aseXML SCHEMA CHANGE REQUEST

PREPARED BY:	PIUS KURIAN
DOCUMENT REF:	CR 41
VERSION:	1.1
DATE:	16 FEB 2011
DRAFT/FINAL	FINAL

Change Request 41 proposes to modify the ServiceOrderRequest aseXML transactions by increasing the CoC field length from seven to eight.

Figure 2-2 GasServiceOrderDetails

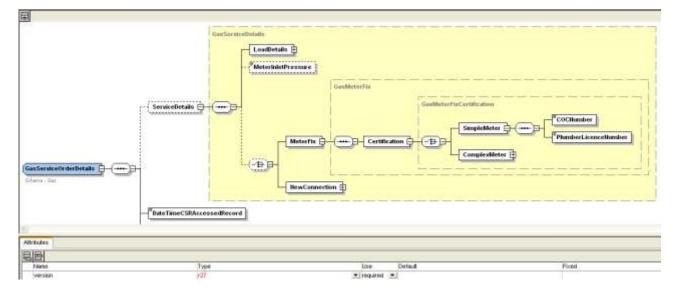
The version attribute of GasServiceOrderDetails has been revised to r27.
